**1. INSTALLATION OF TRAFFIC CONTROL SIGNAL AND ROADWAY MODIFICATIONS
AT CYRVILLE AND MEADOWBROOK - PUBLIC HEARING**

Our File/N/Réf. **50 20-00-R128H**
Your File/V/Réf.

DATE 25 September 2000

SUBJECT/OBJET **CYRVILLE ROAD AND MEADOWBROOK ROAD
PRELIMINARY DESIGN - TRAFFIC CONTROL SIGNAL
INSTALLATION AND ROADWAY MODIFICATIONS**

ANNEX C

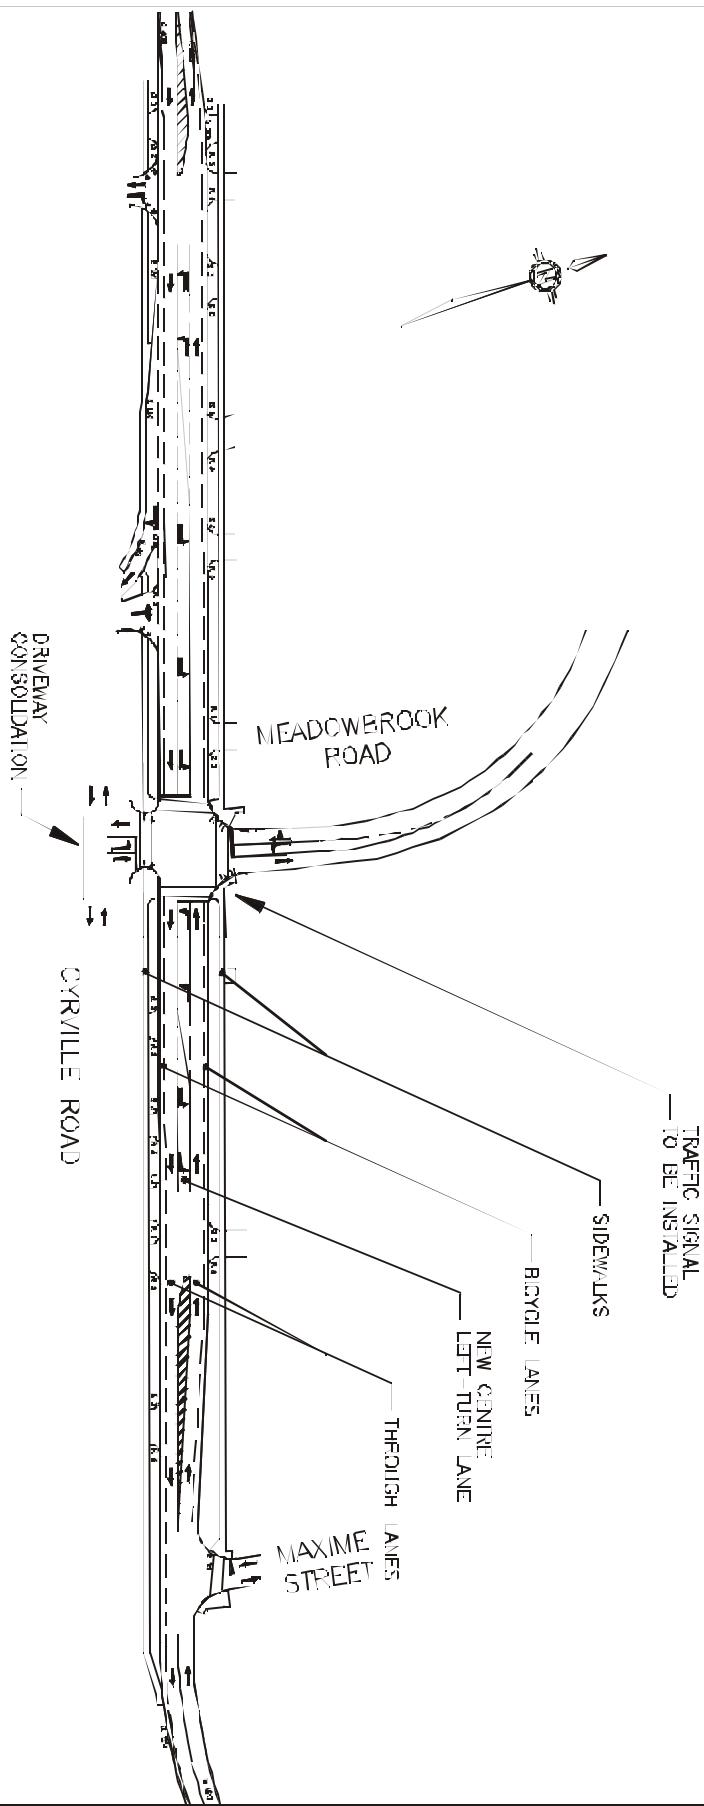
The Regional Cycling Advisory Group (RCAG) wishes to comment on the characterization of bicycle lanes being safer than mixed use lanes.

RCAG has clearly stated to RMOC staff in earlier reports that bicycle lanes are for comfort and convenience. Bicycle lanes do not necessarily provide a safer environment for cyclists.

We support the general recommendation and proposed installation of bike lanes,
but do not support the justification.

Councillor Bellemare indicated there was a desire by the community to have bus shelters installed on both sides of the road. He noted that such installation falls under the mandate of OC Transpo and they have advised that this location is not a high priority for shelters at this time, because of low ridership levels. The councillor explained that the cost to install such a facility is \$6000, \$1500 of which is for the concrete slab and given that sidewalks will be constructed during this project, he believed that cost could be waived. He was of the opinion that when a road is being upgraded from a rural to an urban standard, consideration should be given to installing bus shelters and other amenities to encourage transit use. He proposed the following:

That a concrete pad and bus shelter be installed for each of the two bus stops located on either side of Cyrville Road, for a total cost of \$9,000 with funds to be provided within the total estimated cost of this project.

Having held a public hearing, that Council approve the preliminary design for the new intersection on Cyrville Road and Meadowbrook Road including proposed roadway modifications as shown in Annex C as amended by the following:

- a. that a concrete pad and bus shelter be installed for each of the two bus stops located on either side of Cyrville Road, for a total cost of \$9,000 with funds to be provided within the total estimated cost of this project, and that where appropriate, the installation of bus shelters be included within the scope of all transportation capital projects.

That a concrete pad and bus shelter be installed for each of the two bus stops located on either side of Cyrville Road, for a total cost of \$9,000 with funds to be provided within the total estimated cost of this project, and that where appropriate, the installation of bus shelters be included within the scope of all transportation capital projects.
